World Forum for Harmonization of Vehicle Regulations**Working Party on Noise and Tyres****Seventy-fifth session**

Item 4 (e) of the provisional agenda

Tyres: UN Regulation No. 141 (Tyre pressure monitoring system)**Proposal for Supplement 2 to the 01 series of Amendments to
UN Regulation No. 141****Submitted by the Task Force on Tyre Pressure Monitoring System and
Tyre Installation***

“Figure 1
Refilling check

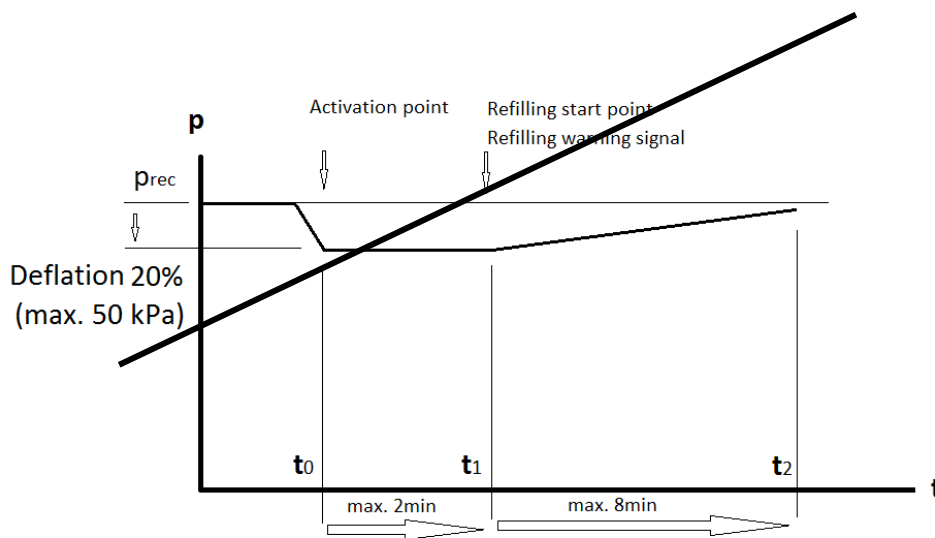
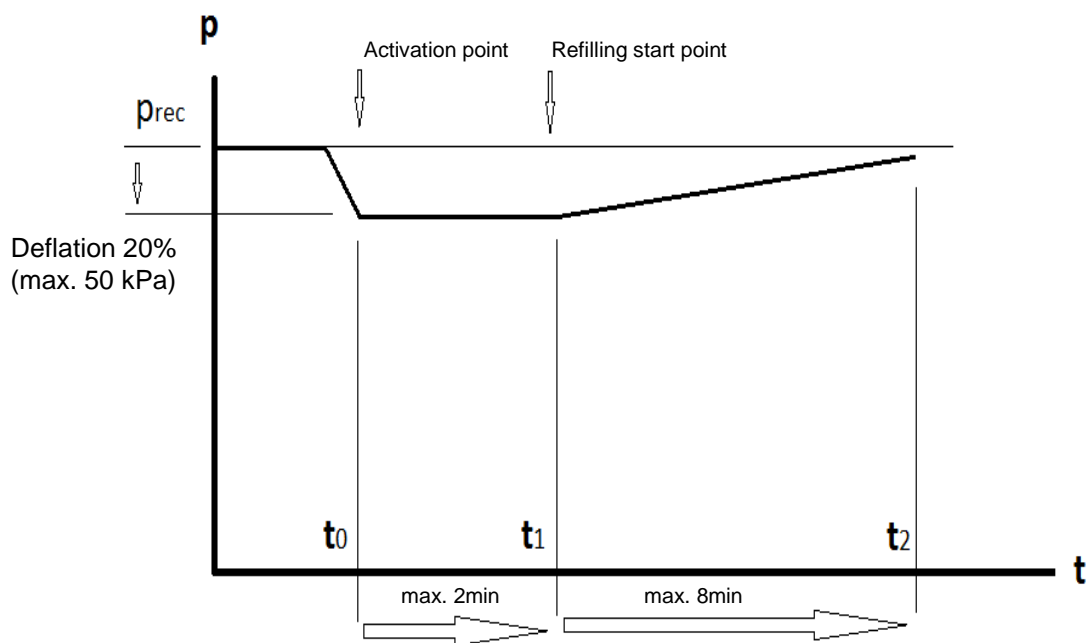
Figure 1, amend to read:

- “2.25.1. Check refilling according to Figure 1**

Check that within 2 minutes, when the system is operational, the TPRS/CTIS starts refilling and at least after 2 minutes the low tyre pressure tell-tale, as described in paragraph 5.5. of the Regulation, is “On”.

Refill process shall be completed within 8 min after the refill process has started and the low tyre pressure tell-tale, as described in paragraph 5.5. of the Regulation, is “Off” as soon as the refilling process is completed.

After the refilling process has been completed, check that the tyre pressure is in a range of +/- 5% of manufacturers recommended cold inflation pressure P_{rec} .”

“Figure 2

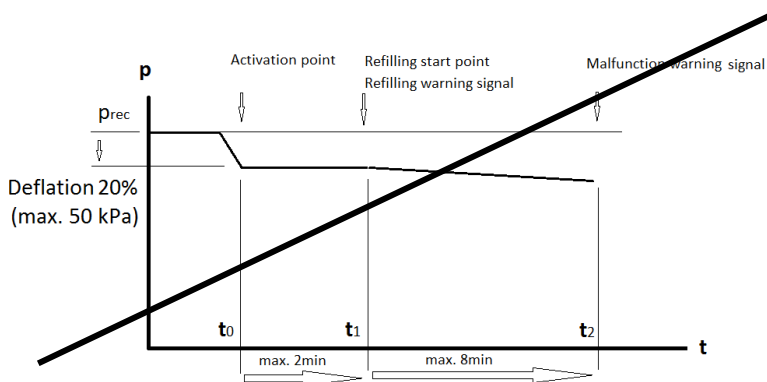
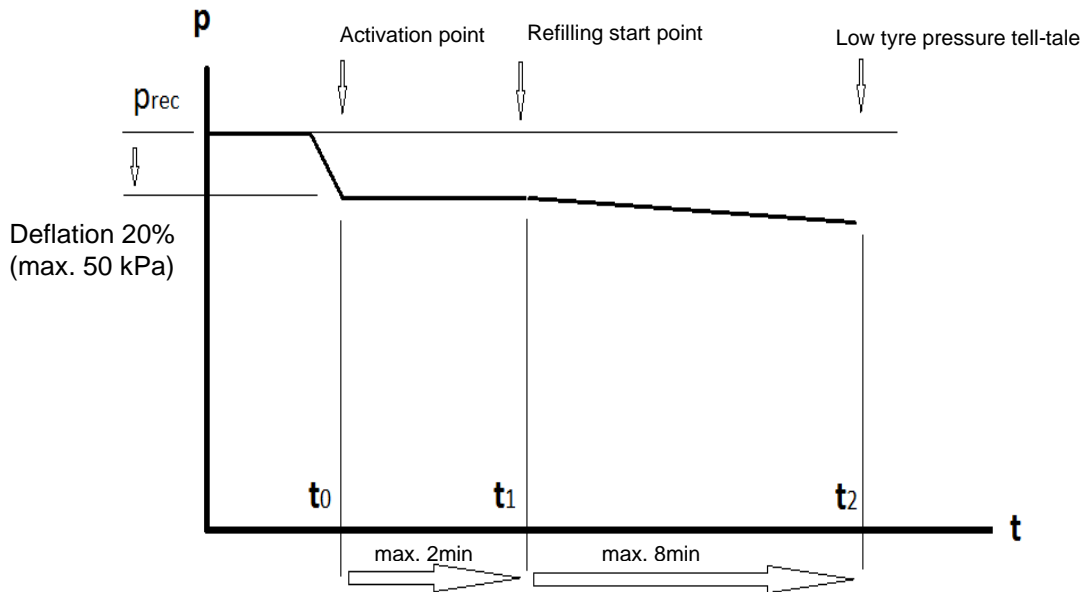
Figure 2, amend to read:

“2.5.2. Check refilling according to Figure 2

Check that within 2 minutes when the system is operational the TPRS/CTIS starts refilling and at least after 2 minutes the low tyre pressure tell-tale, as described in paragraph 5.5. of the regulation, is “On”.

Refill process shall not be completed within 8 min after the refill process has started and the low tyre pressure tell-tale, as described in paragraph 5.5. of the regulation, is “ON” after at least 2 minutes of refilling time.

The deflation rate during the test must be higher than the refilling rate.”

“Figure 1

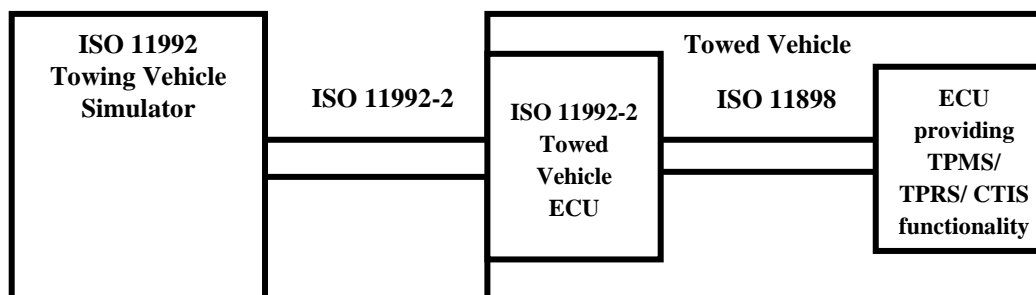
Figure 1, amend to read:

Arrangement of device under test and vehicle simulator where TPMS/ TPRS/ CTIS functionality is provided by ECU connected via ISO 11898-1:2015 and 11898-2:2016 interface

“Figure 2

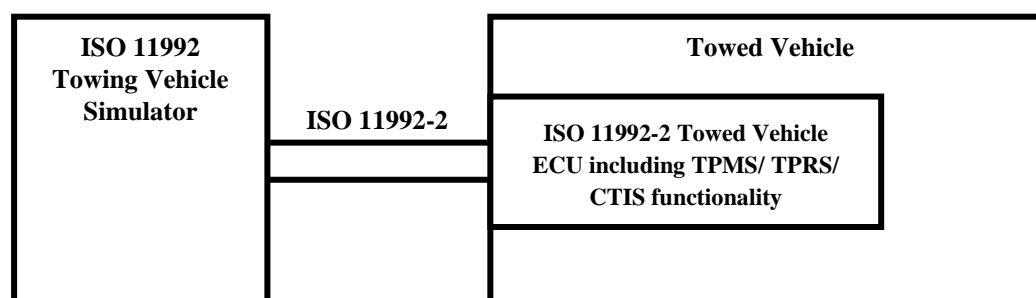
Figure 2, amend to read:

Arrangement of device under test and vehicle simulator where TPMS/ TPRS/ CTIS functionality is provided by ECU connected to towing vehicle
